**Representation in response to Initial Assessment Report - Kangaroo Bay Hotel
Major Project**

Kangaroo Bay Hotel Major Project

Representation to the Assessment Panel's Initial Assessment Report

Connection to Surrounding Environment

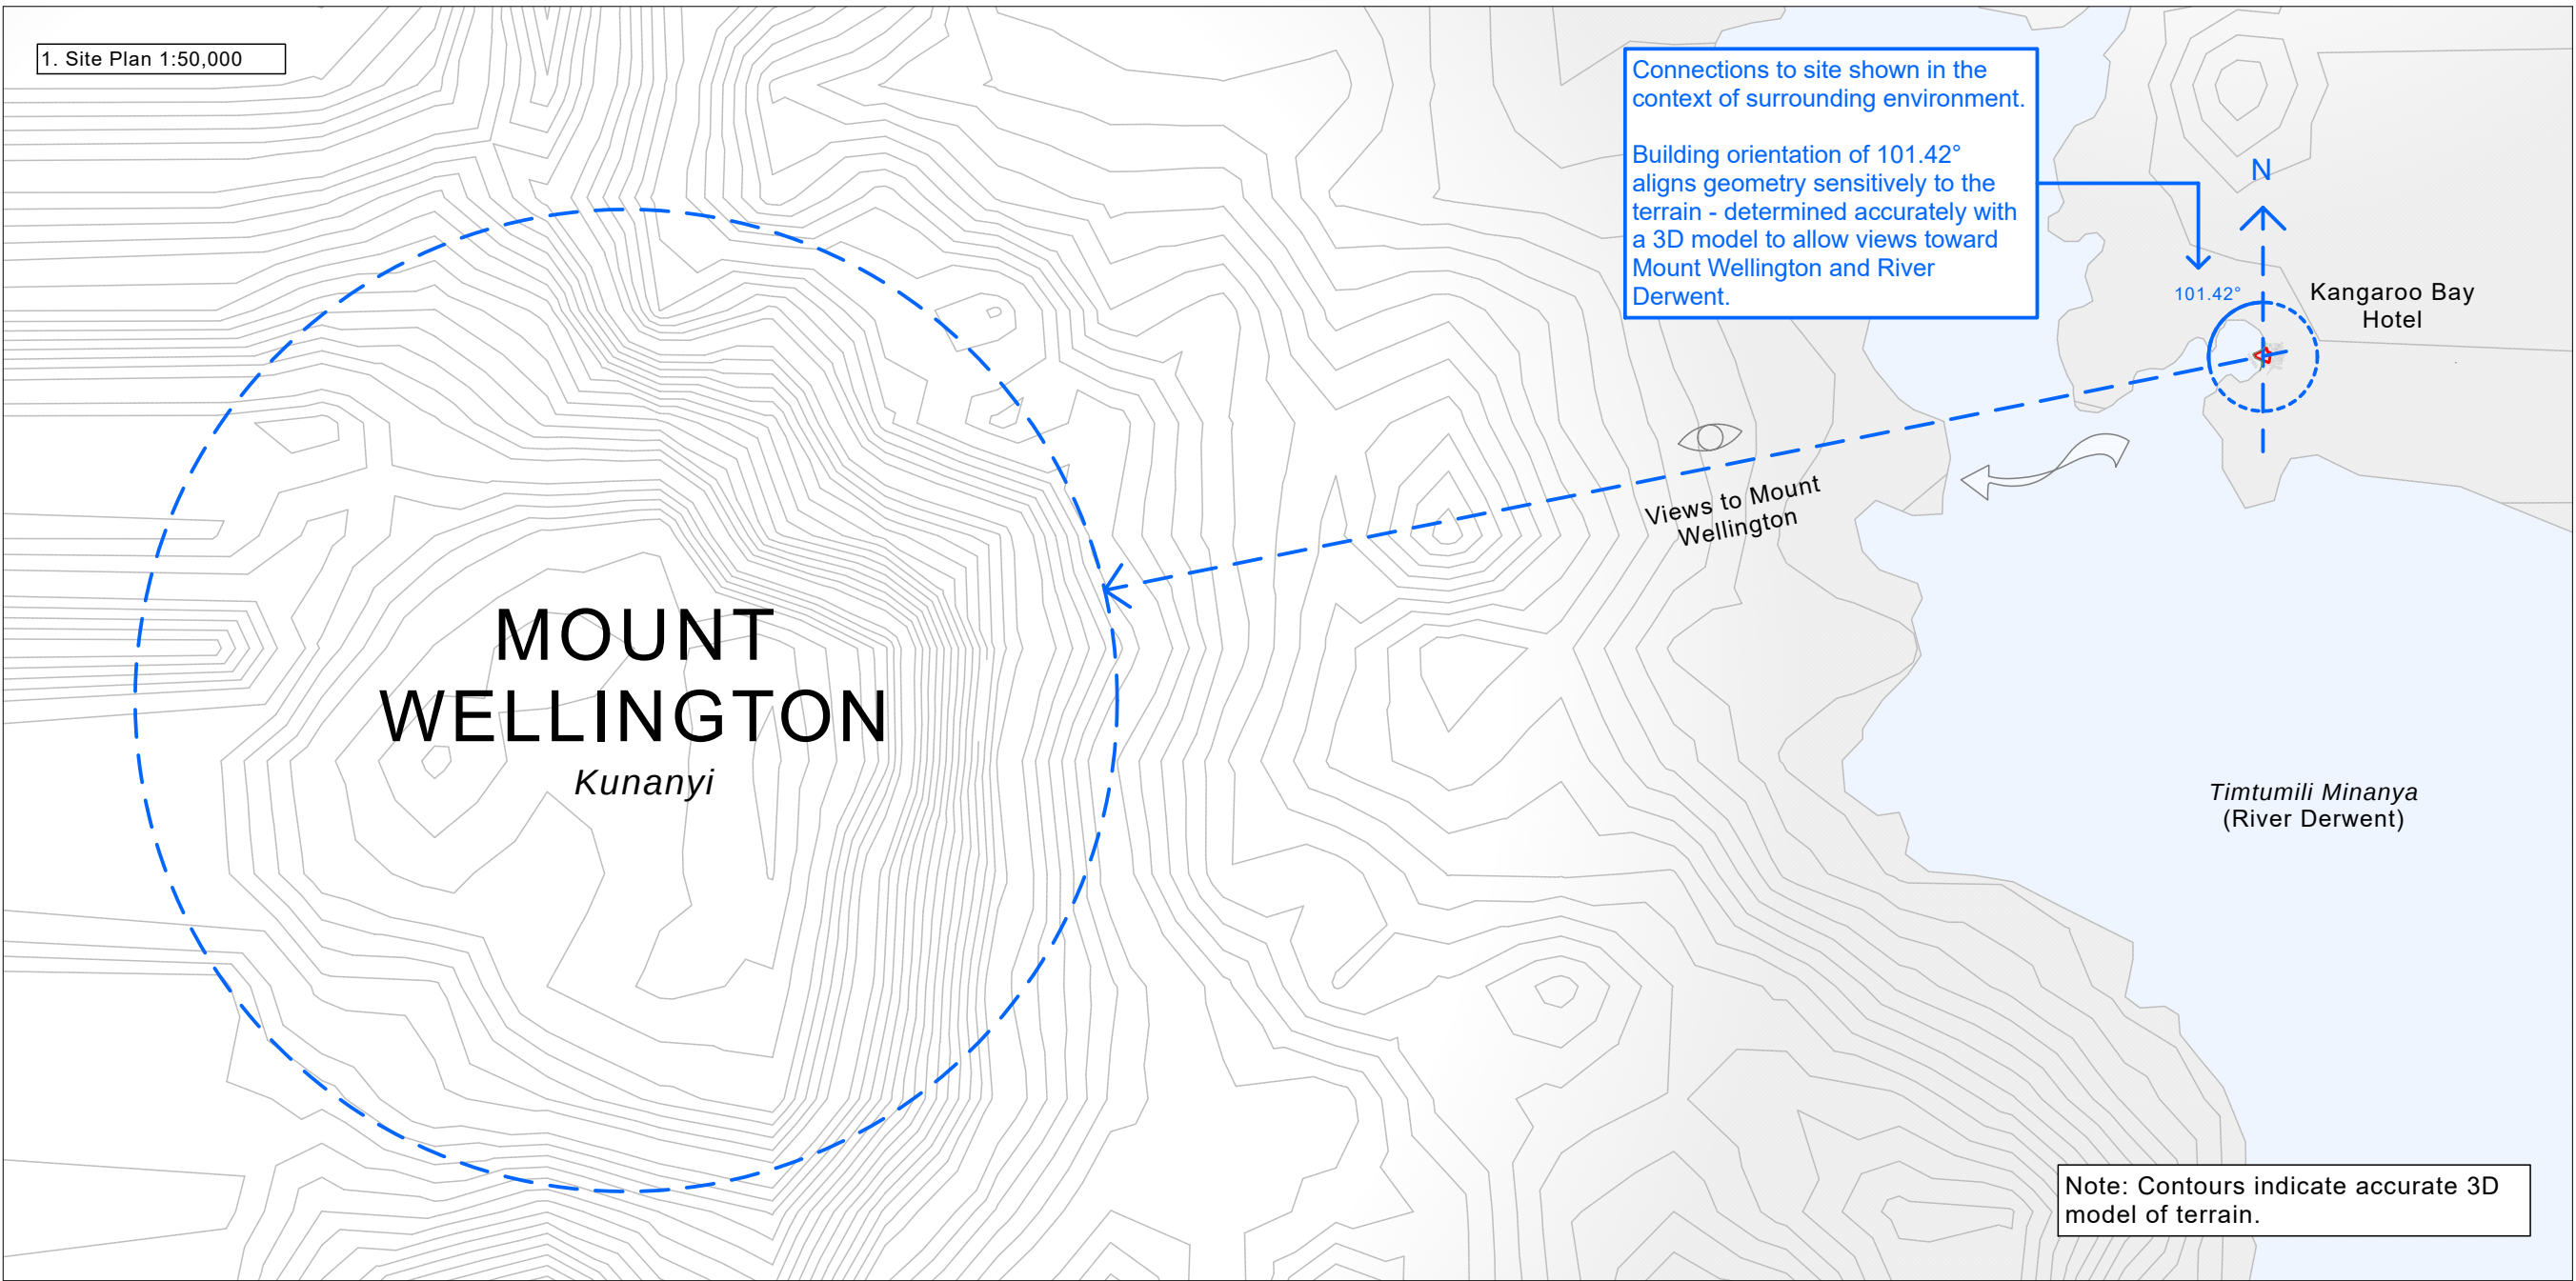
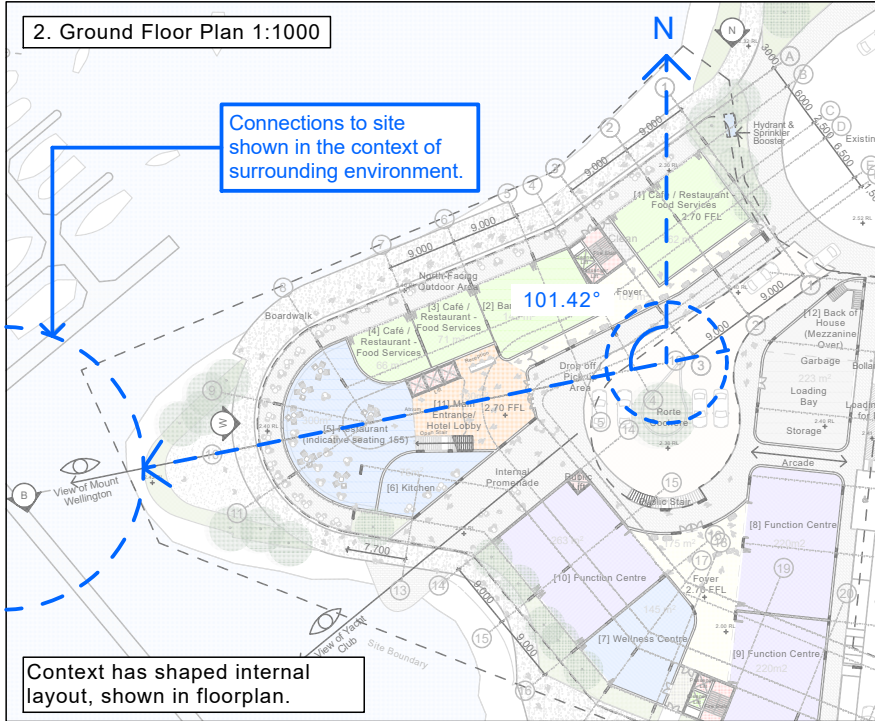
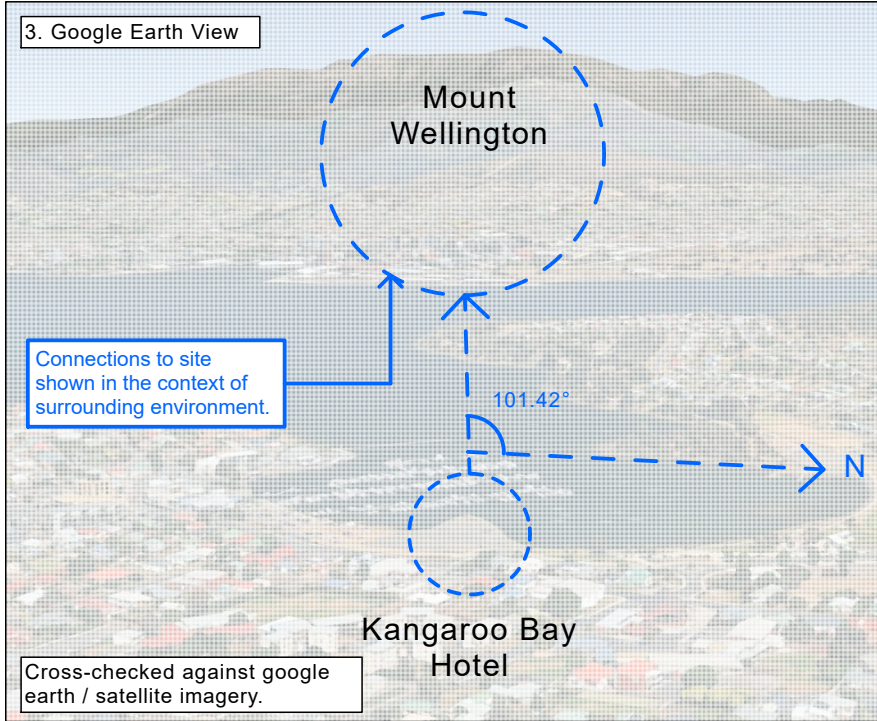
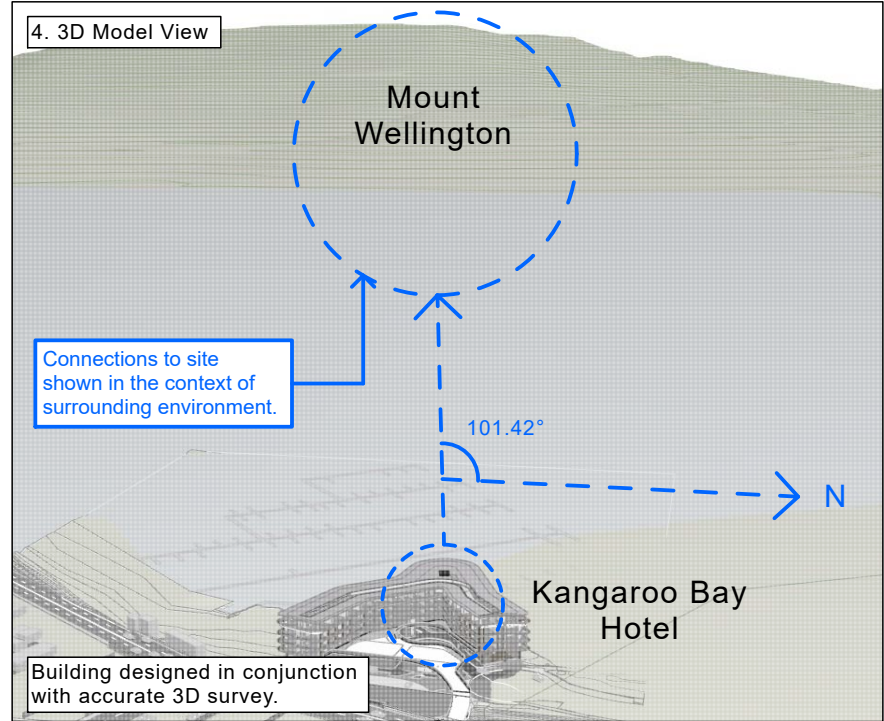
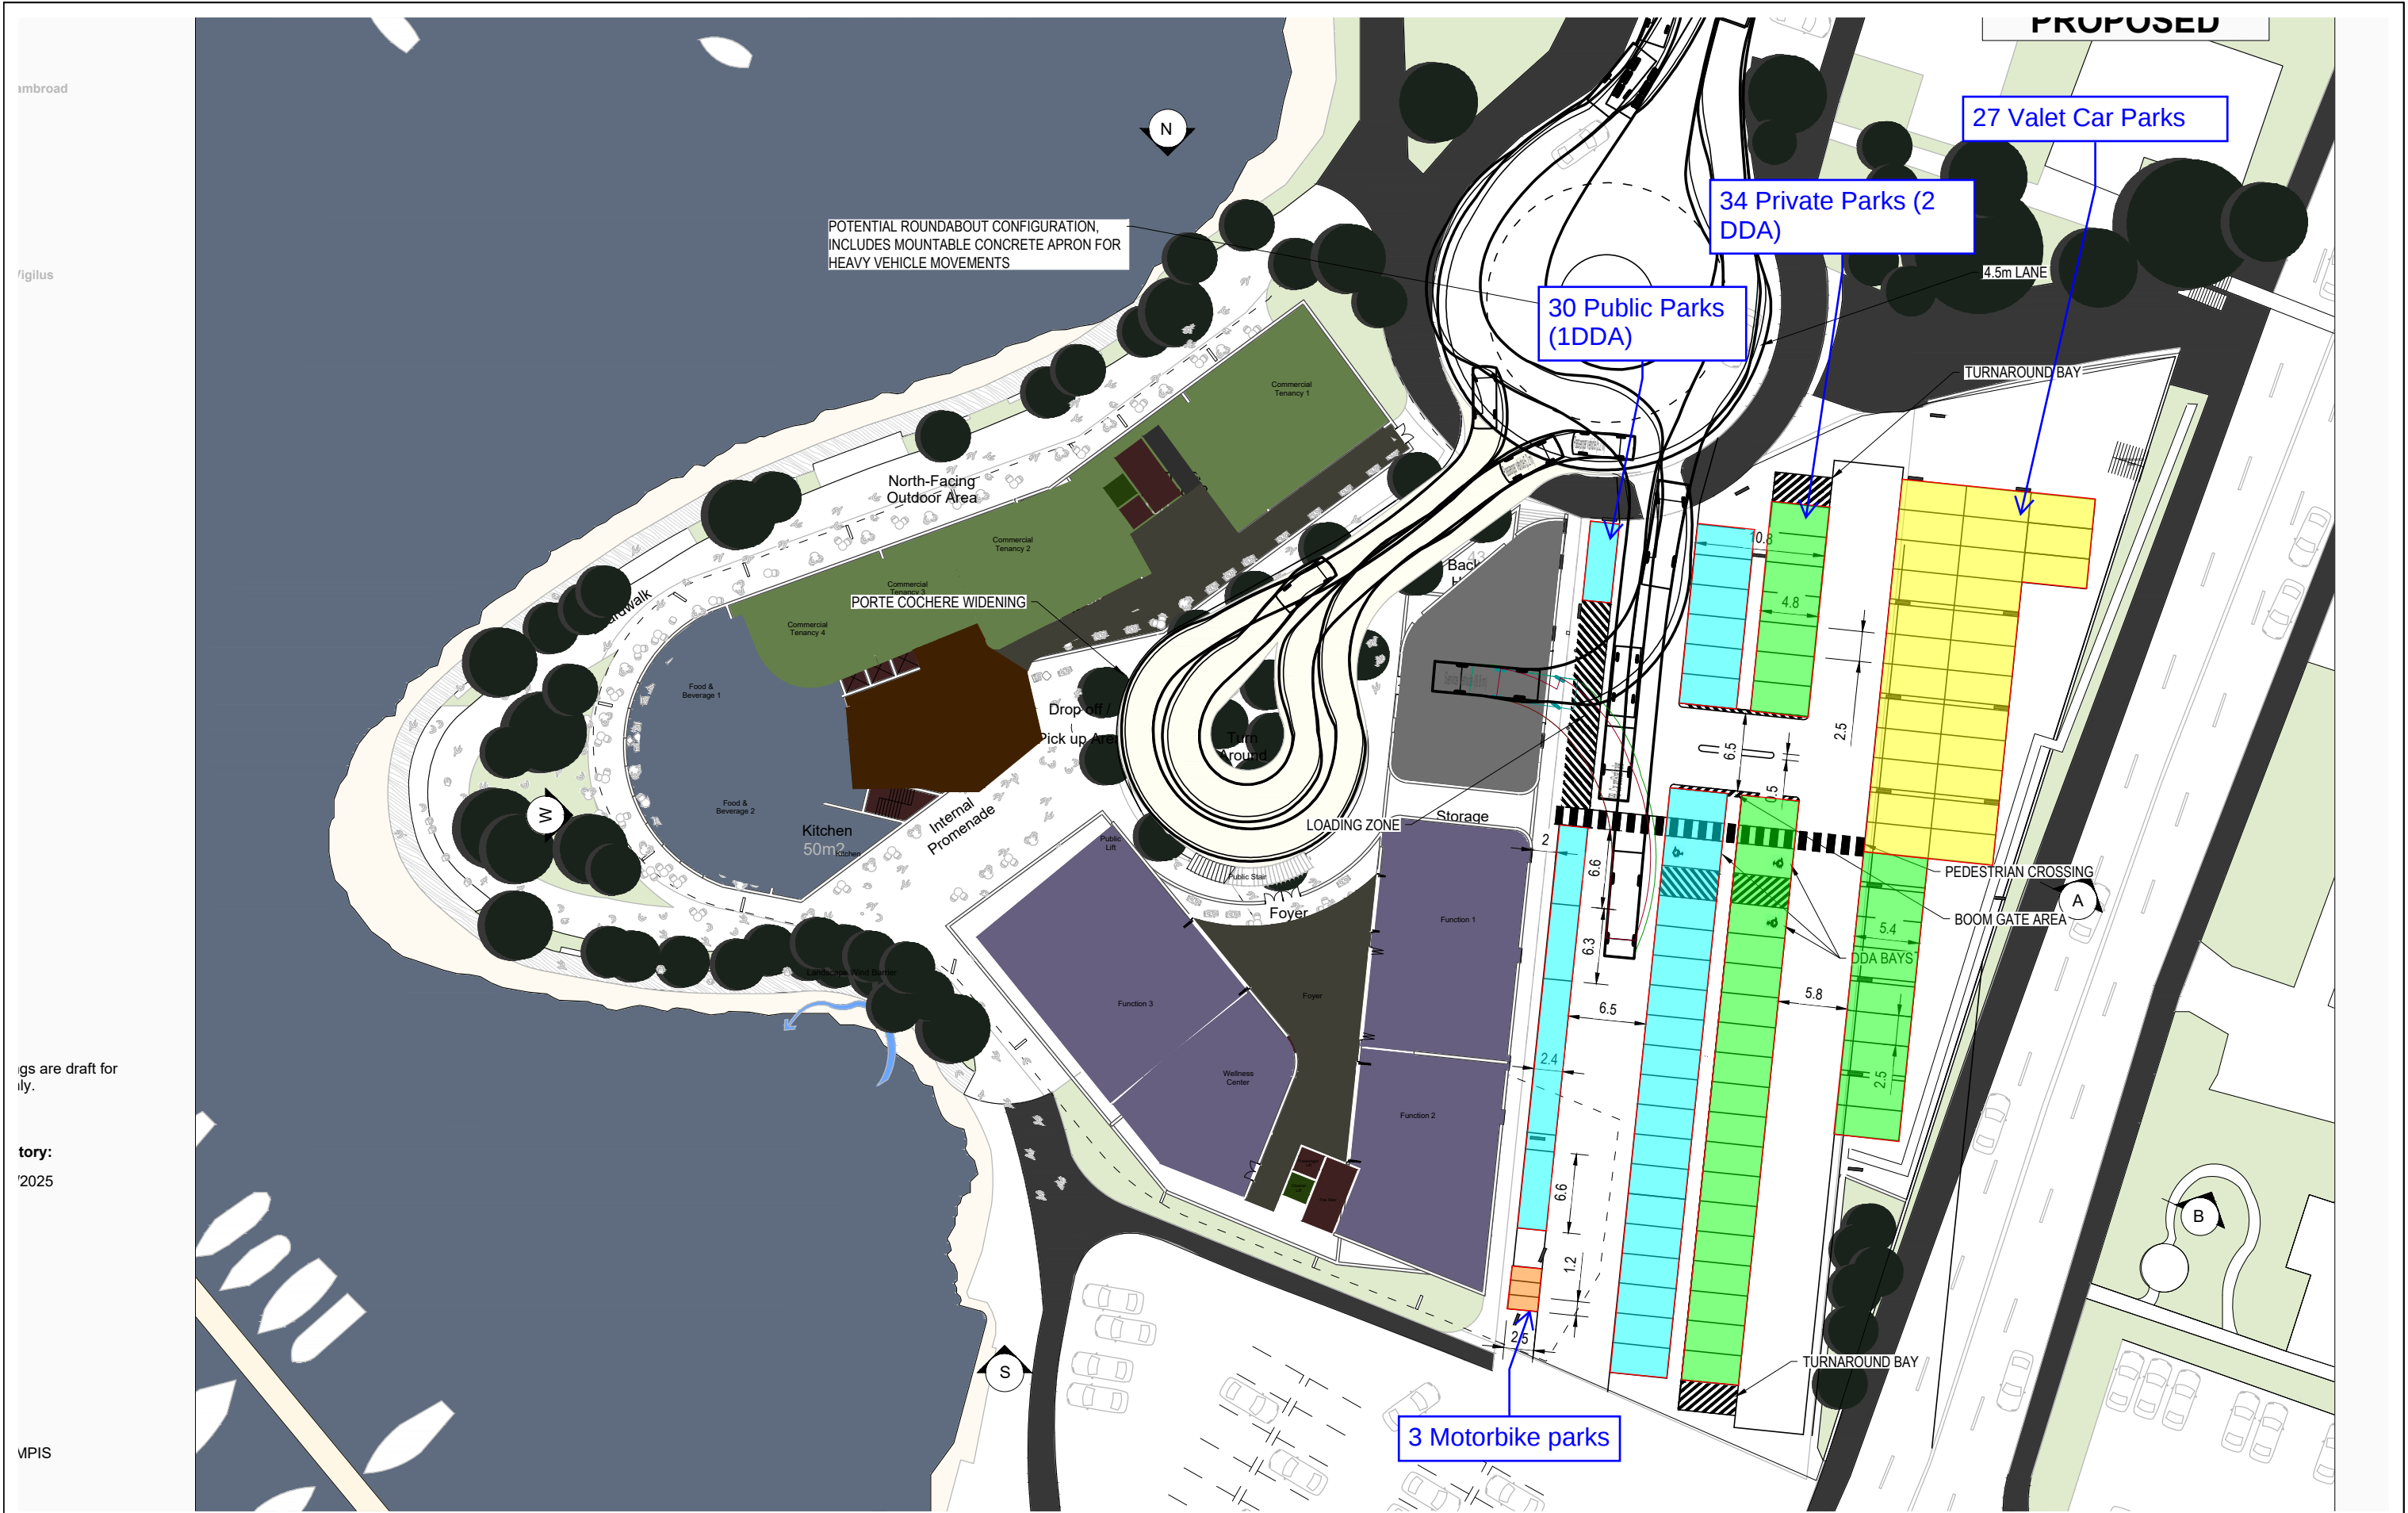
- The connection to Timtumili Minanya/River Derwent and Kunanyi/Mount Wellington is demonstrated via montages showing view lines from inside the building, but not in the context of the surrounding environment.
- The Visual Impact Assessment, which shows the Project in its surrounding environment, does not illustrate the proposed external materials or colours of the building to demonstrate how these respond to the context of the surrounding landscape.
- The architectural plans provide a preliminary external material schedule including glass, timber look cladding, concrete and metal cladding. The specifications of the proposed materials are not provided, limiting information on the Project's visual response to the surrounding environment.

Item 3 in Attachment B to this Representation is a new drawing to demonstrate the Project's connection to Timtumili Minanya/River Derwent and Kunanyi/Mount Wellington in the context of the surrounding environment.

The drawing shows the site connection based on four views:

1. Site Plan 1 : 50,000
2. Ground Floor Plan 1 : 1000
3. Google Earth View
4. 3D Model View.

The drawing shows how the building orientation and geometry aligns sensitively with the surrounding environment and terrain.
